Addendum Number 1

Issued 4/26/2024

Franklin Active Adult Center (AAC)

160 E. Adams St.
Franklin, IN 46131

ROOF TOP UNIT SCREEN ELEVATIONS

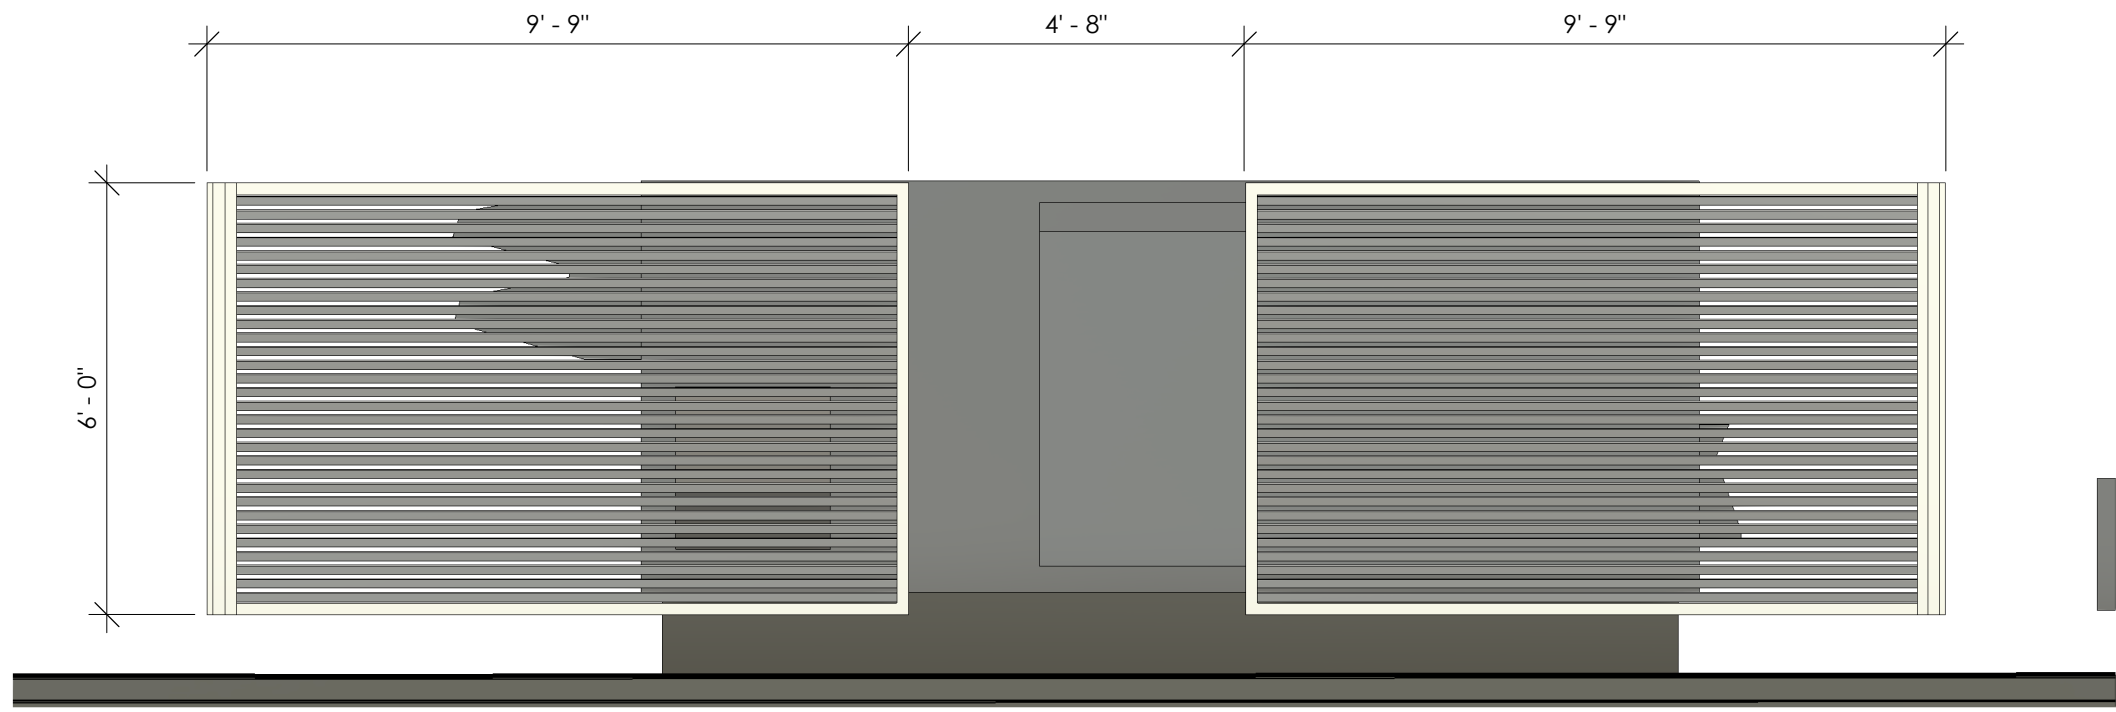
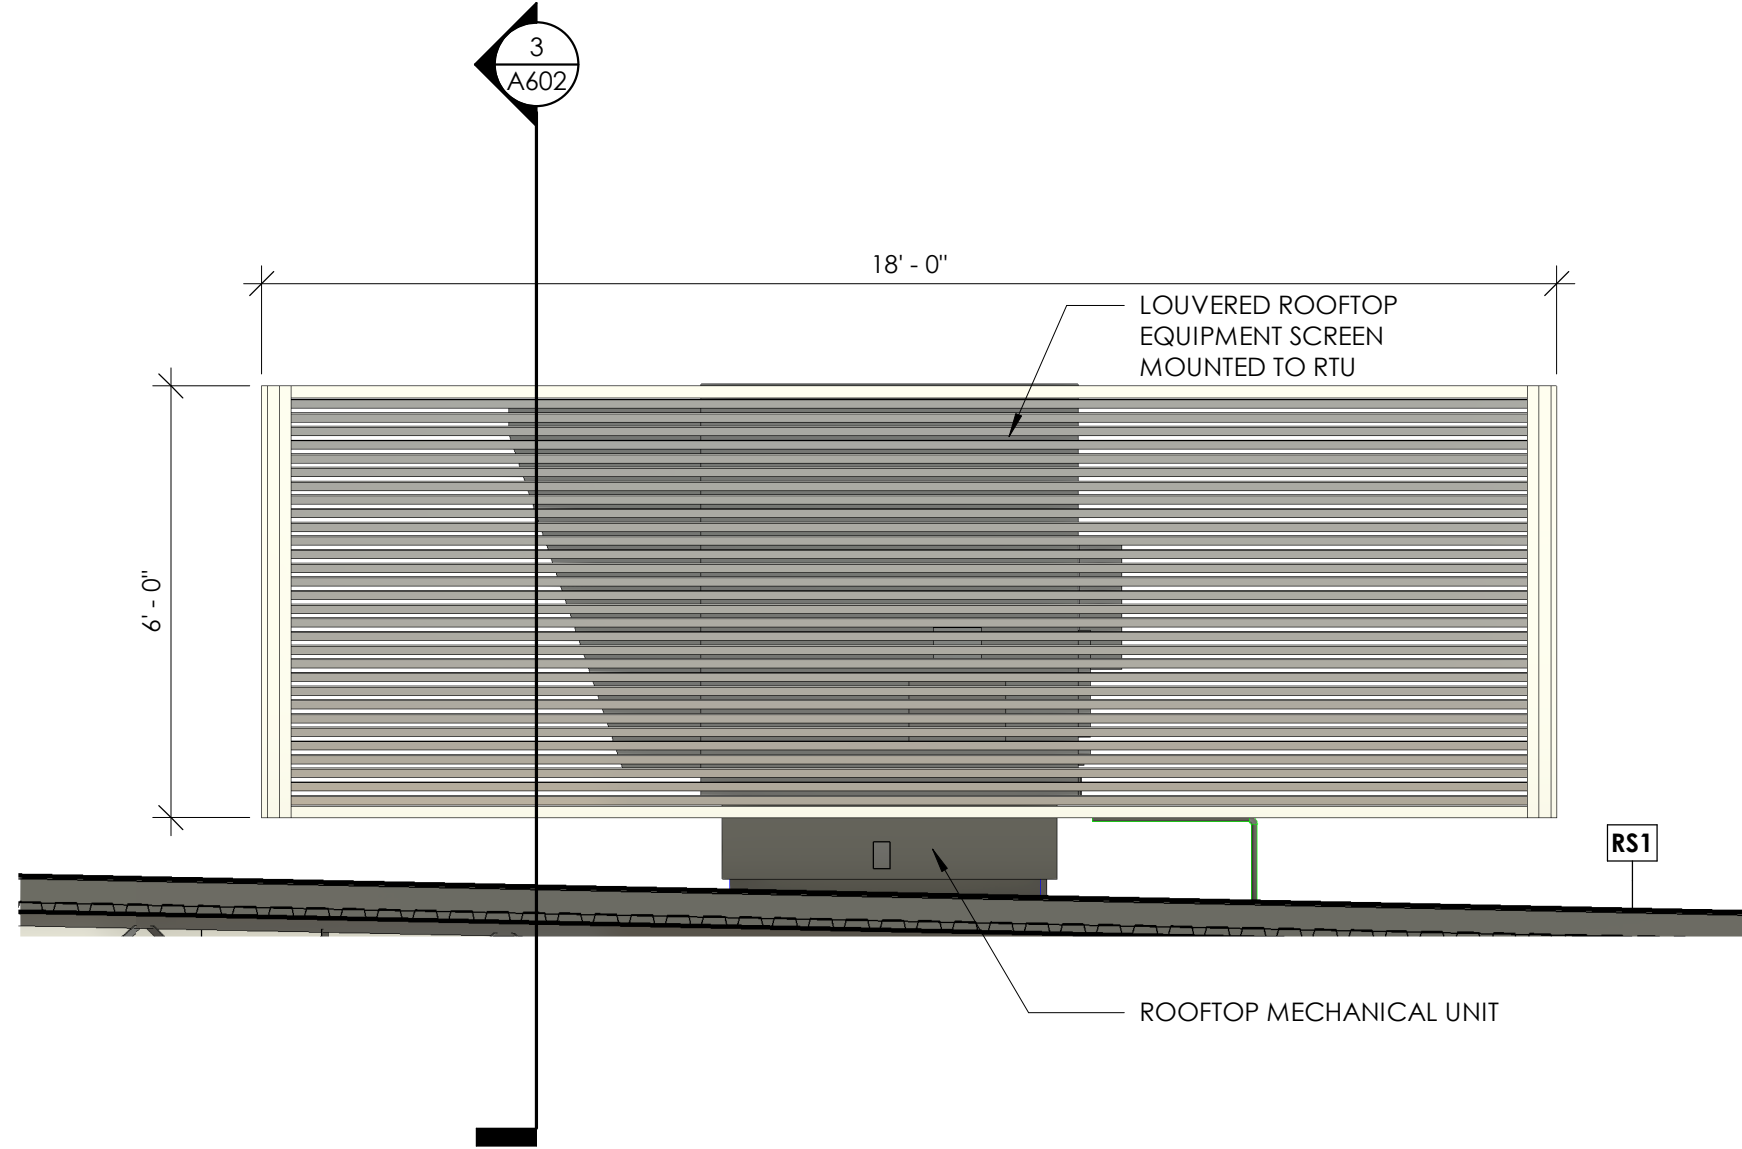
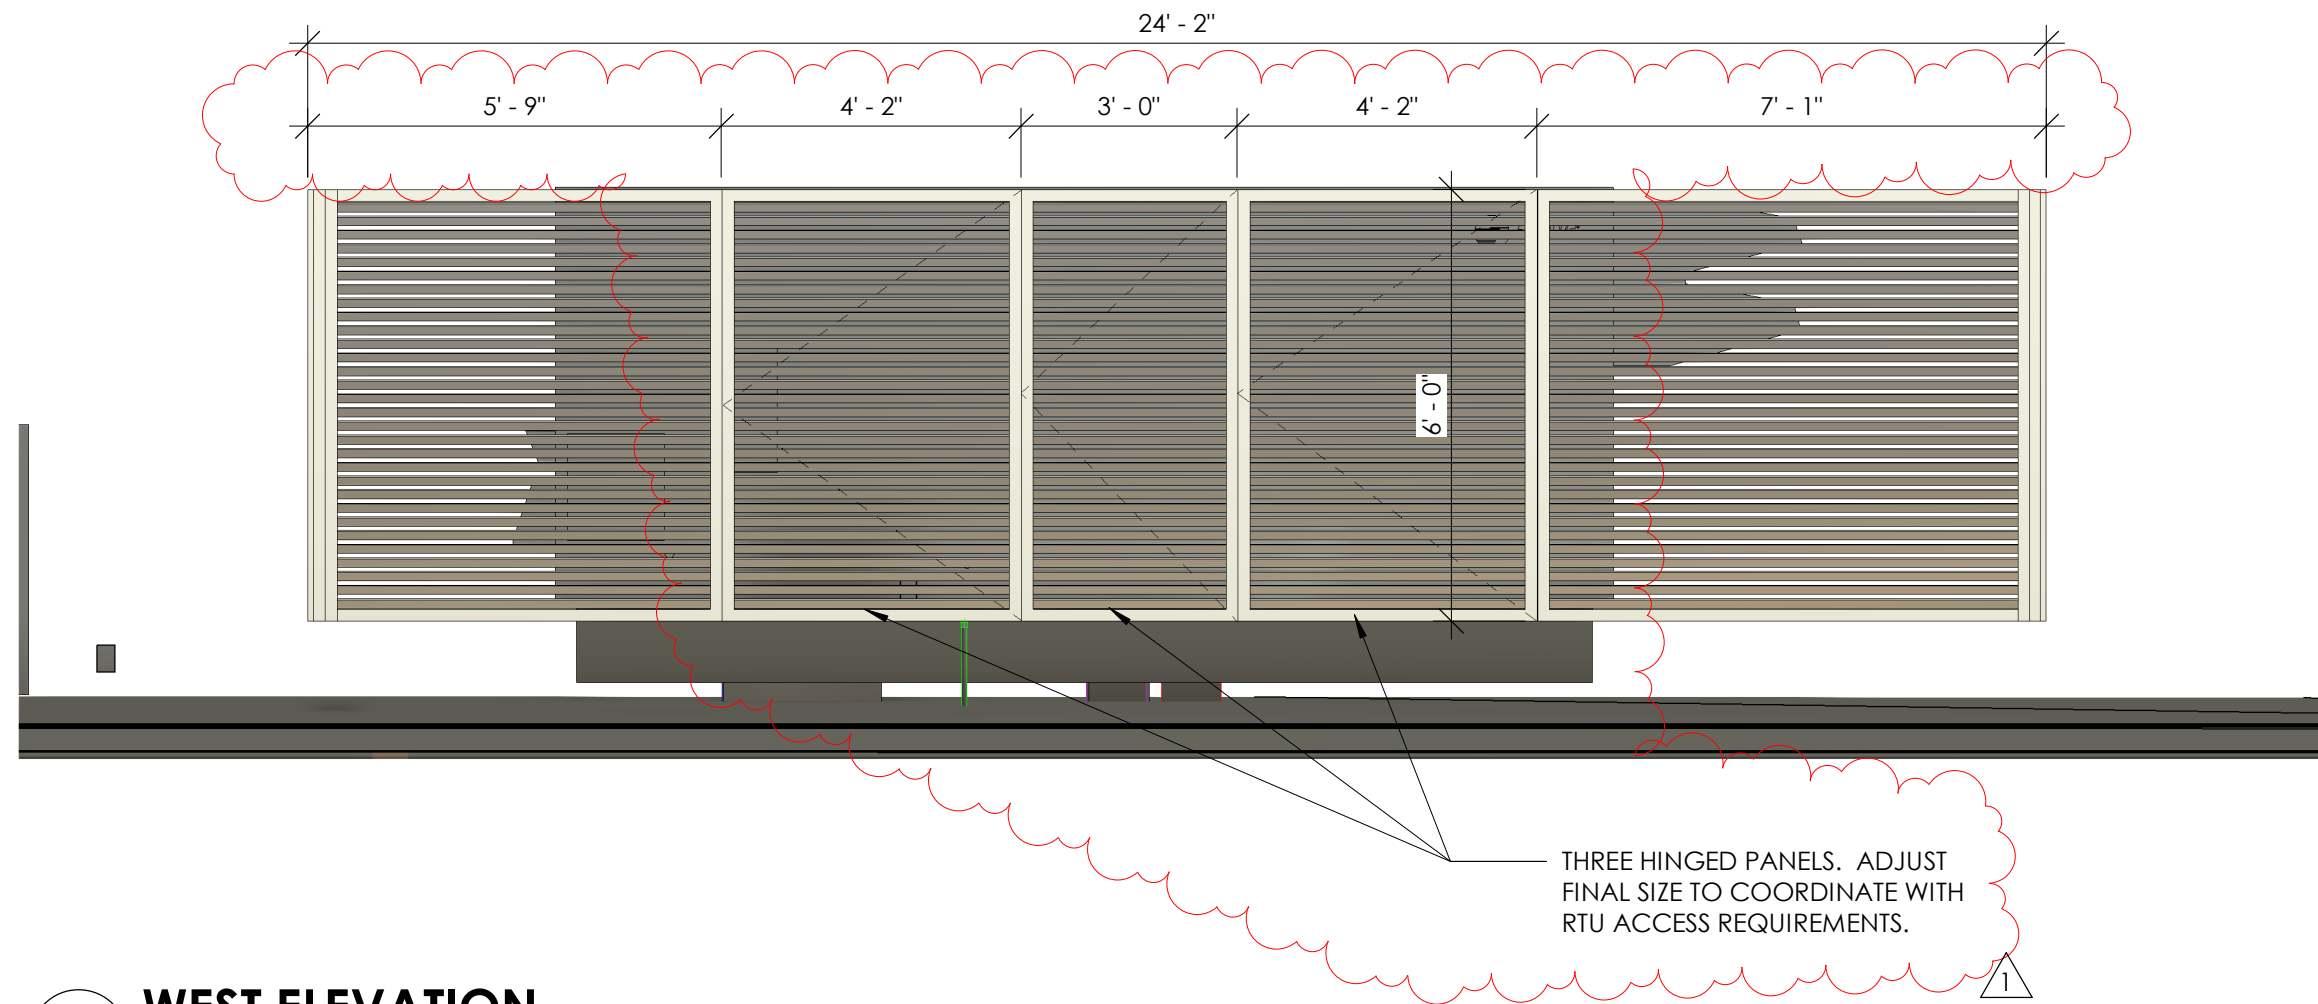
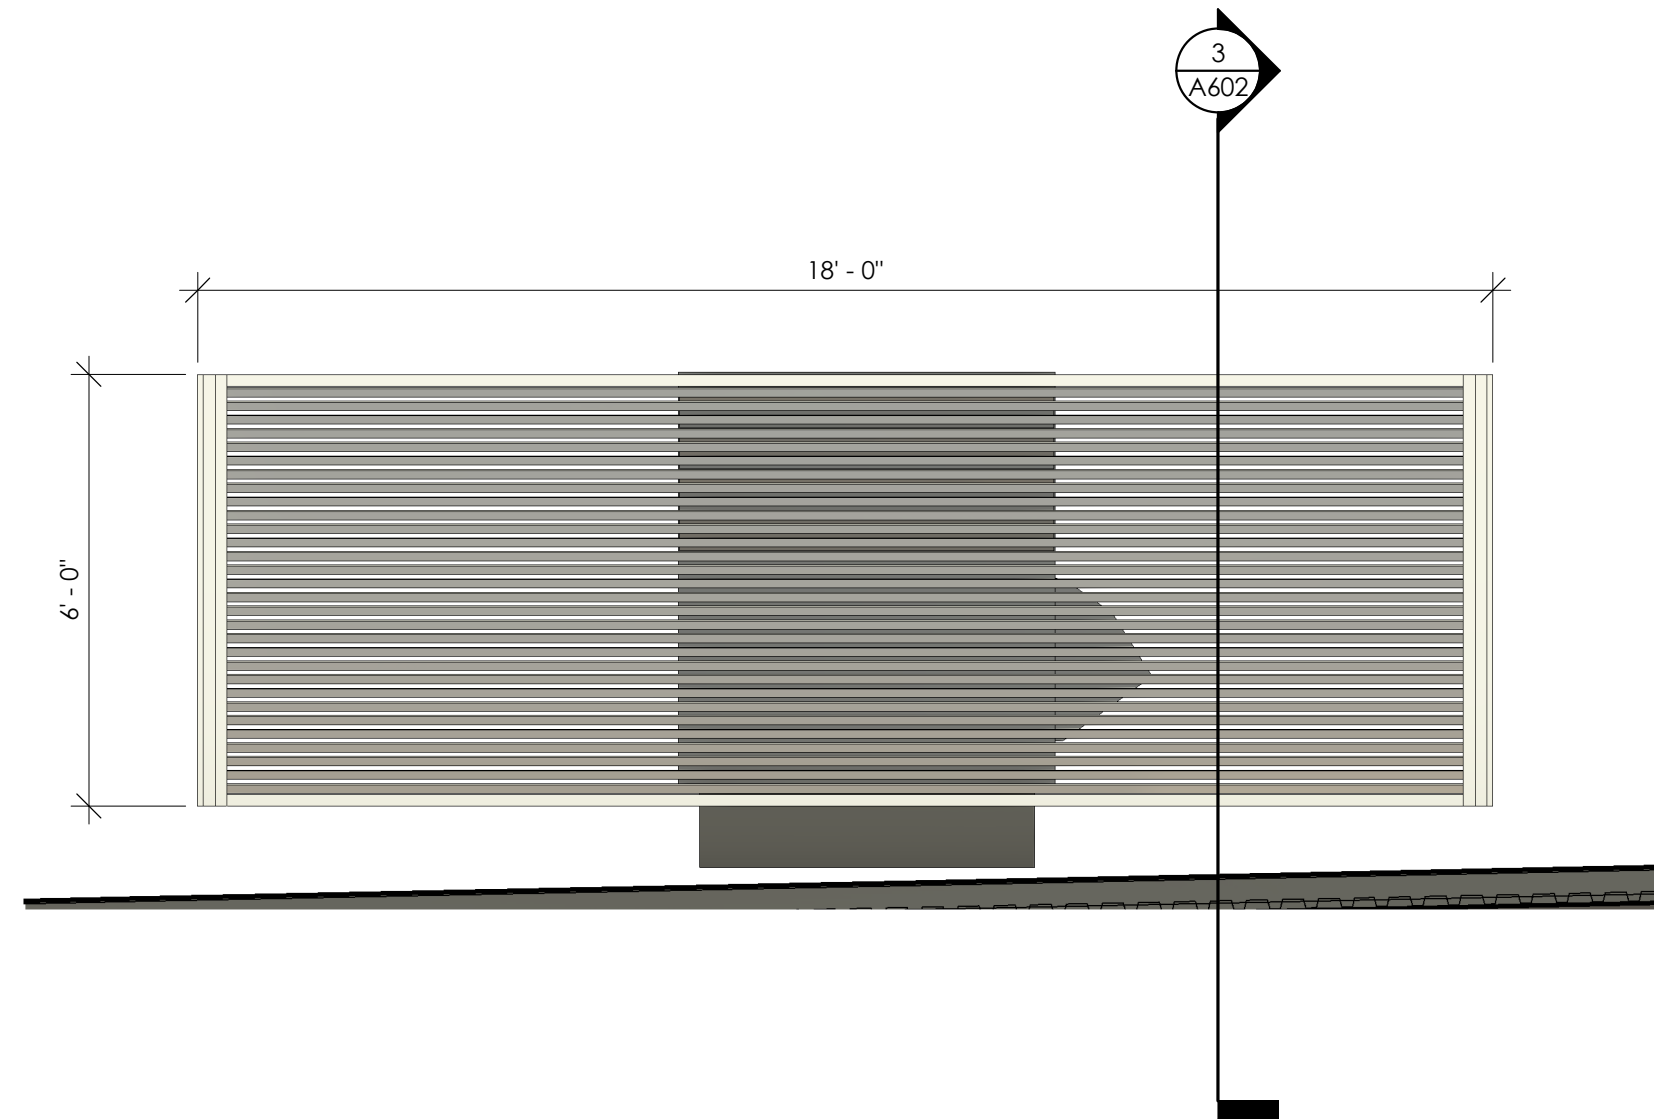
- Item No. 29** Sheet A401 & A403: Add hinged panels to RTU Enclosure. Attached.
- Item No. 30** Sheets A501 and A502: At North and East Elevations, delete notes calling for expansion joints in V-Groove Aluminum Siding and revise keynote 7.09 to "NOT USED."
